RE: PROPOSED NANNUP ALPINE RESORT
LOT 500 BROCKMAN HIGHWAY– NANNUP (WA)

Response to Authority and Community Comments in relation to the advertising period of the Local Development Plan for the above project.

RE: VULNERABLE TOURISM LAND USE – LOT 500 BROCKMAN HIGHWAY, NANNUP – LOCAL DEVELOPMENT PLAN

Figure 3a: Vegetation Classification

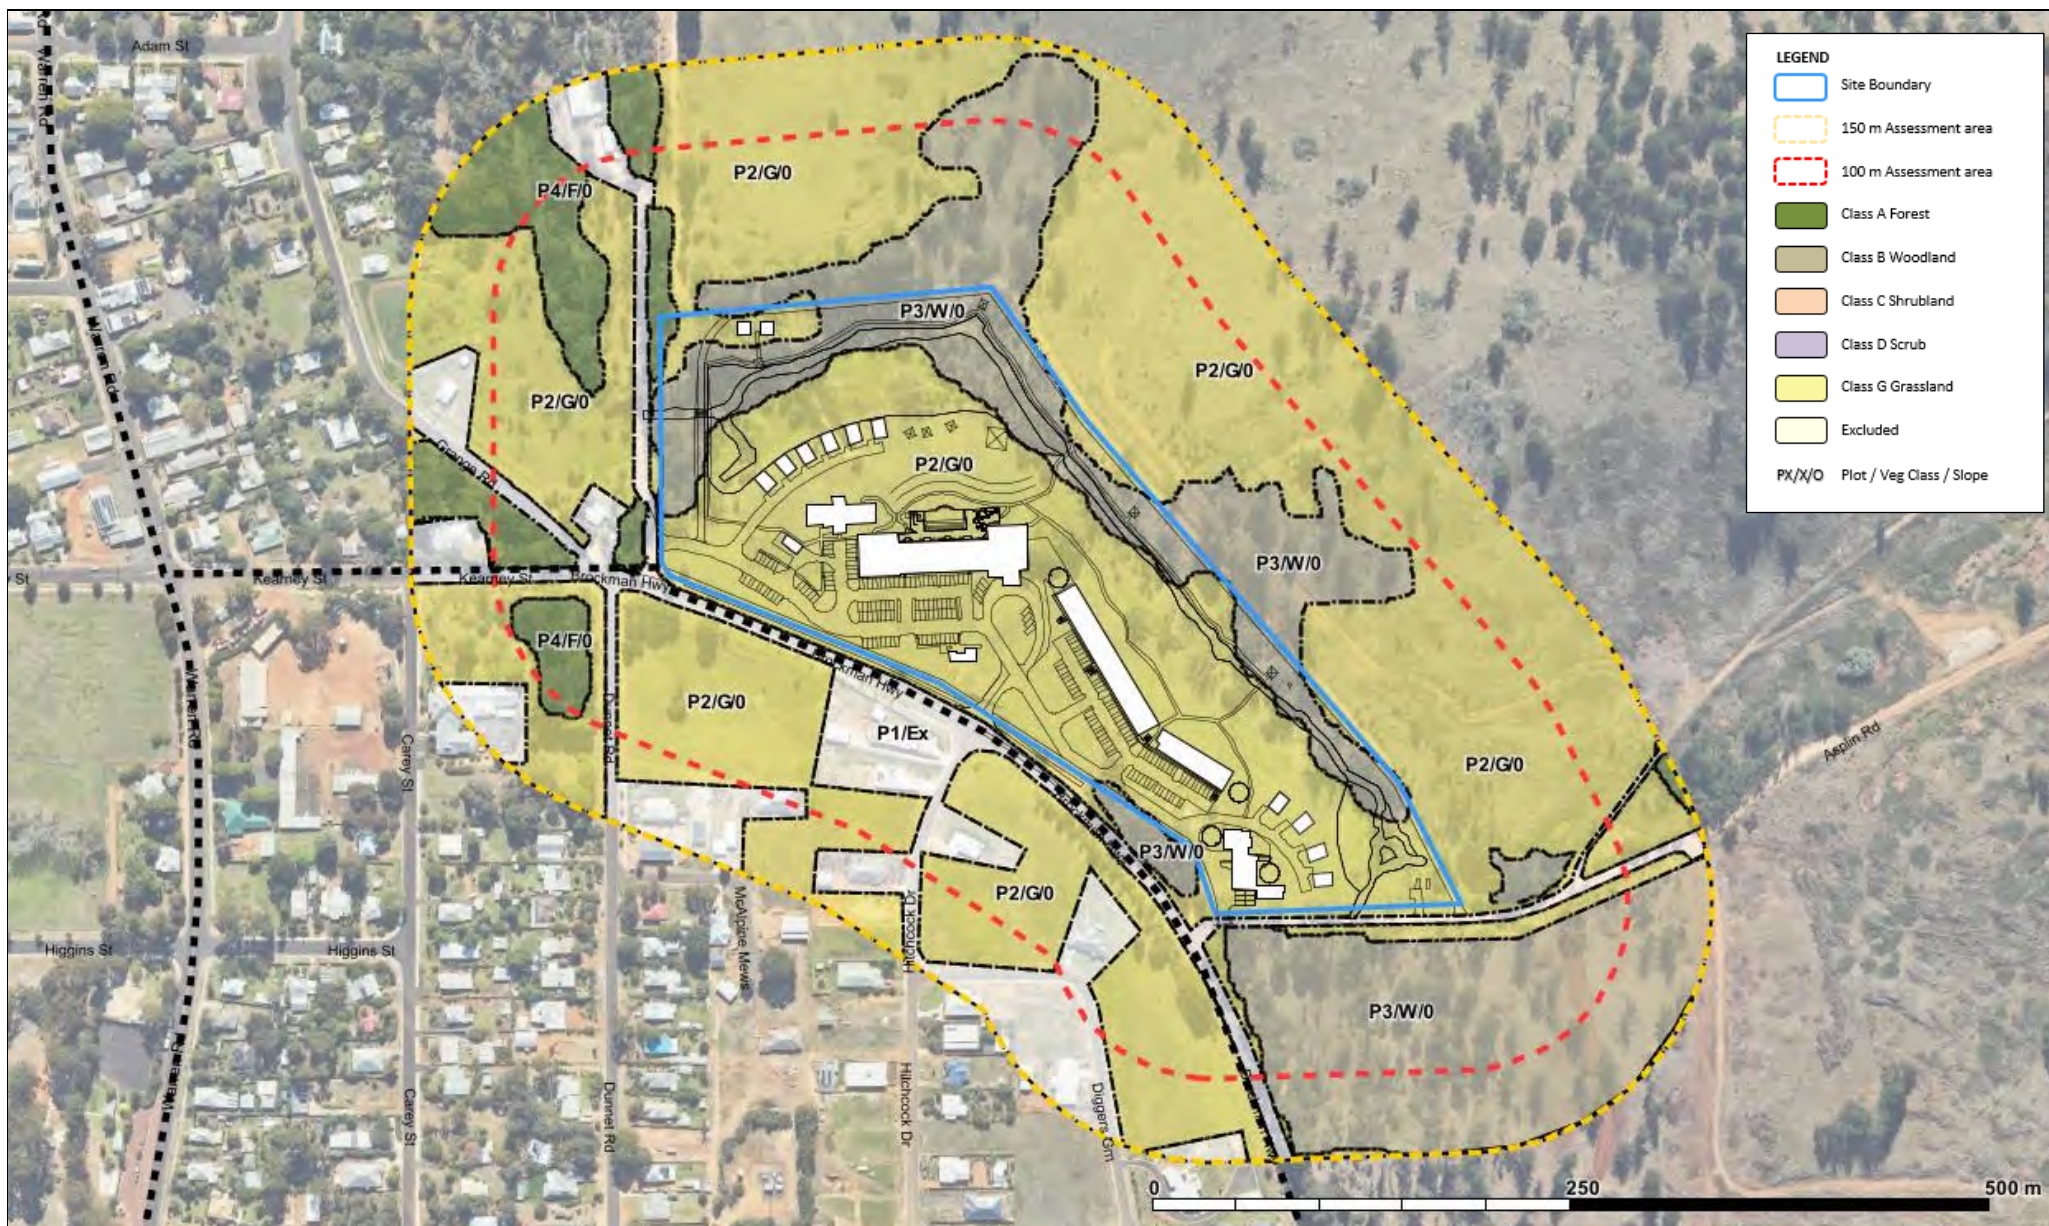
Assessment	Action
Vegetation plot 2 cannot be substantiated in its entirety as Class G Grassland, including the area south/adjacent to Asplin Road. The potential for revegetation has not been considered. The BMP should detail specifically how the Class G Grassland classification was derived as opposed to Class B Woodland. If unsubstantiated, the vegetation classification should be revised to consider the vegetation at maturity as per AS3959, or the resultant BAL ratings may be inaccurate.	AS 3959:2018 requests revegetation is considered only where there is a recent and short-term modification. C2.2.3.1 <i>'Vegetation classes may appear to be modified as a result of previous landuses, clearing, weed invasion or due to disturbances which may affect short term fire behaviour...the presence of disturbance by bushfire or past use does not in itself warrant any reduction in the classification of the vegetation, the potential for revegetation should be considered'</i> The assessment is not required to anticipate all possibilities. The purpose of this clause is to stop advantageous immediate clearing to achieve a favourable construction outcome. The exception is where it is known changes will occur such as establishing a forest within POS, as may be formally documented in a strategic level document. Notwithstanding the above, the southern verge of Asplin Road if reclassified as Woodland would not change the ratings to the nearest buildings, either the southernmost unit or the workshop. No change to the BMP is required

Vegetation plot 3 cannot be substantiated in its entirety as Class B Woodland. Plot 3 has been assigned to two distinct and separated areas.	The Plots are based upon the vegetation class, there is no requirement for a separate Plot for the same class in another location. The purpose of the

The BMP should detail specifically how the Class B Woodland classification for plot 3 to the west was derived as opposed to Class A Forest. If unsubstantiated, the vegetation classification should be revised to consider the vegetation at maturity as per AS3959, or the resultant BAL ratings may be inaccurate.	georeferenced photos is the evidence of class in a location. For the purpose of distinguishing the flame length and the radiant heat level the classification of Forest and Woodland is distinguished by the understory type and not the canopy. This is described at Figure 2.2 and Table B3 in AS3959:2018. Woodland is distinguished by a grass understorey. The Plot 3 photos are georeferenced (location taken) and show a grass understory. No change to the BMP is required, but an additional photo 3.3 has been added.
As per Appendix 3 of the Guidelines, a vegetation classification table is required, but has not been provided in the BMP. While DFES notes that Table 2 – Recorded distances for the BAL at each habitable building provides the vegetation adjacent to each building, the inputs for classified vegetation and defined slope for each plot should be recorded in a table format.	Appendix 3 in the Guidelines does not require a vegetation table? The DFES statement is contradictory, because, as identified by DFES, a classification table was provided in the BMP? It should be noted that a BAL contour Map (provided in the BMP) is discretionary for a development application. It gives a complete (sophisticated) picture of proximity and radiant heat levels (for all buildings), rather just the closest measurement distance to a vegetation type (Plot) – to identify the construction level (highest) that is applicable to a building. The BAL contour is based upon the distance provided at AS3959:2018 table 2.5., and achieves the purpose of a vegetation table, it indicates the BAL level at a building. No change to the BMP is required

Figure 5: BAL Contour Excluded Grass

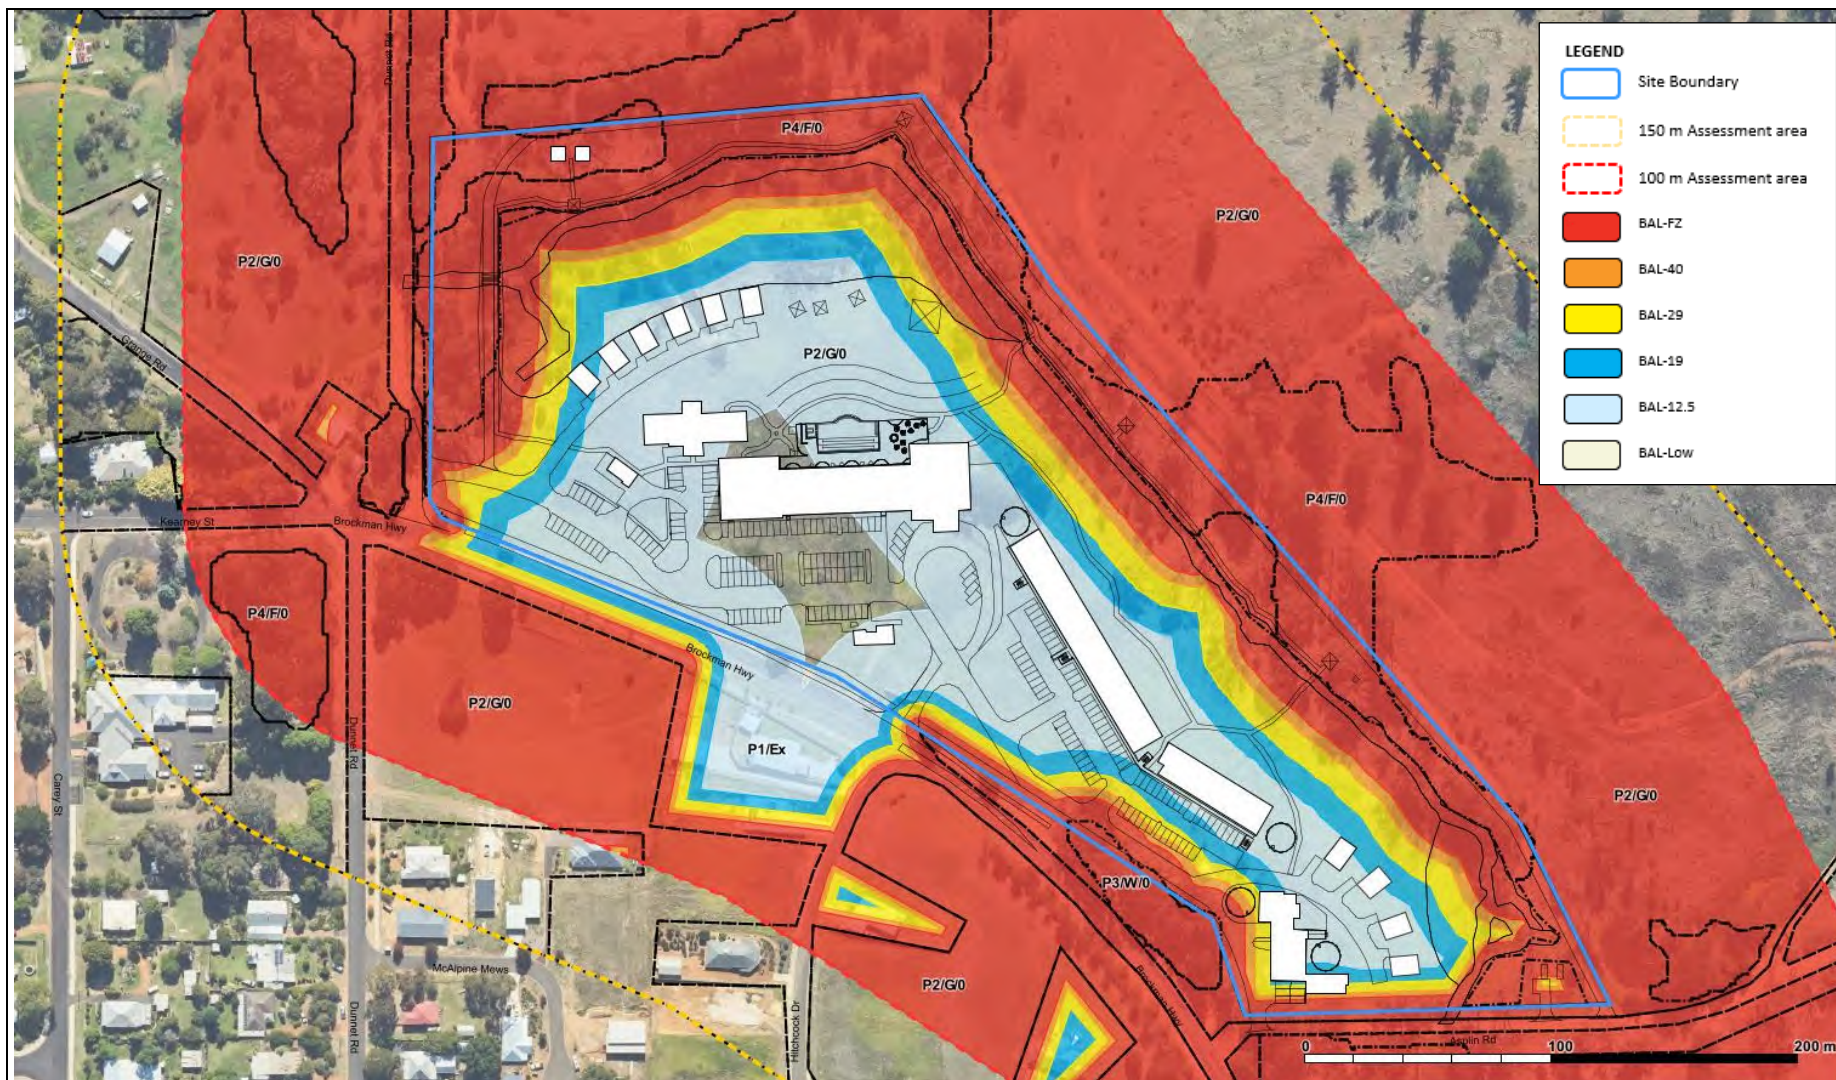
Page 39 of BMP Text “BAL 29 can be achieved at the managers residence and workshop through...” – ‘managers residence’ should be replaced with ‘staff accommodation units’.	This follows page 38 and is affected by the sentence order the sentence is correct it refers to the effect of the fence on the managers residence and workshop. The BMP order has been corrected (BMP attached).
Figure 3b contains duplicated photographic points as follows: 2.4 shown twice, in different locations 4.3 shown twice, in different locations	Agree. The redundant (duplicated) photo points, no outcome effect, were removed in the BMP text. Figure 3b has been replaced. No change to the substance of the BMP and any subsequent references have been required. The BMP has been corrected (BMP attached).
Table 2 lists 21-30 for Forest in the column – Distance (m) for BAL 29. According to AS3959:2018 Table 2.5, this should be 21-31.	Forest is less than 31 m, hence 30 m. Agree to amend the BMP, amended 21-<31: to be consistent with table 2.5. The BMP has been corrected (BMP attached).
